IN no.: **IN-150 rev 1.0**

Device affected: **nRF52820-QDAA**

Description of change:

The nRF52820 revision 3 (build code Dx0) introduces four changes to the product.

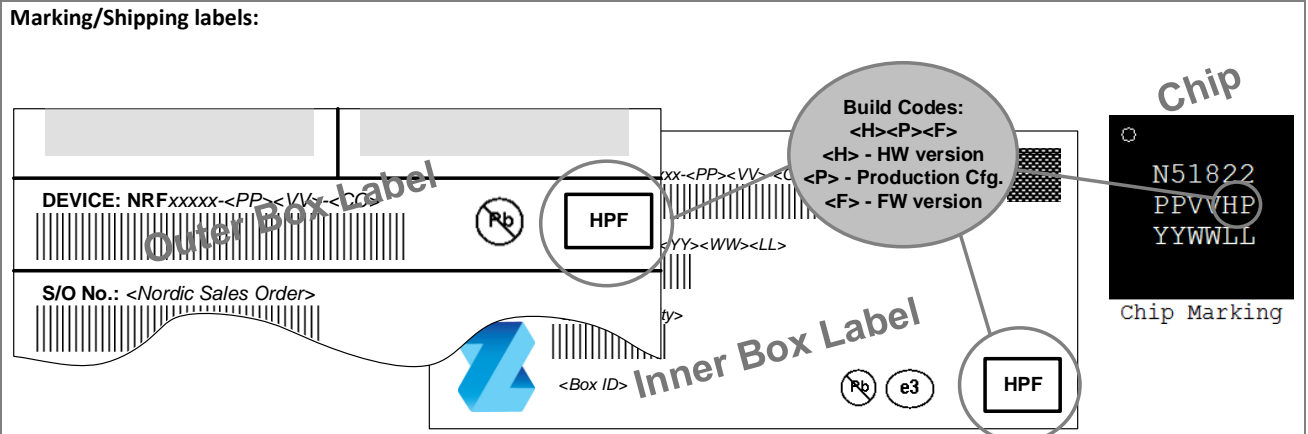
Changes to pin-out:

Existing PCB designs for the nRF52820 (rev. 2) are compatible with the nRF52820 rev. 3 without performance degradation. For new designs an updated bill of material for the reference schematic is available in the product specification rev. 1.2 or later. The new bill of material requires one less decoupling capacitor.

This is to reduce the number of external components. The nRF52820 revision 3 requires one less decoupling capacitor.
